Crank Change/Compatibility

A.C.™ Performance

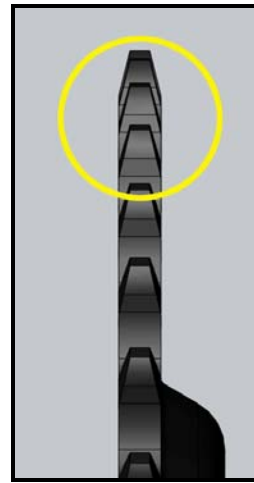
There was a change to the thickness of the crank sprocket, on the A.C. Performance, from 3/32" (2.1mm) to 1/8" (2.6mm). When this change was made, the chain and the flywheel sprocket had to be changed to make them compatible.

3/32" (2.1mm)

1/8" (2.6mm)

If any of these components are mismatched, there will be compatibility or timing issues between the cranks, chain and flywheel sprocket. So it is critical that the correct parts are ordered (based off the serial number of the bike).

Fig.1

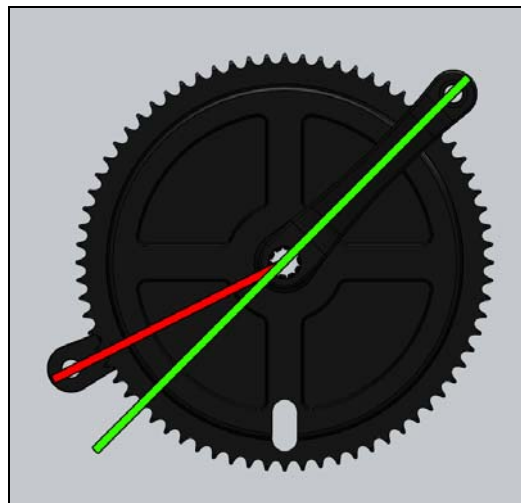
The timing between the 3/32" and 1/8" cranks are different. Should a 1/8" left crank be installed on a bike with a 3/32" right crank/sprocket, the arms will not be aligned (Fig. 1).

When ordering parts for bikes **prior** to serial number **10175GIA11370001**, order the following:

When ordering parts for bikes **after** serial number **10075GIA11370001**, order the following:
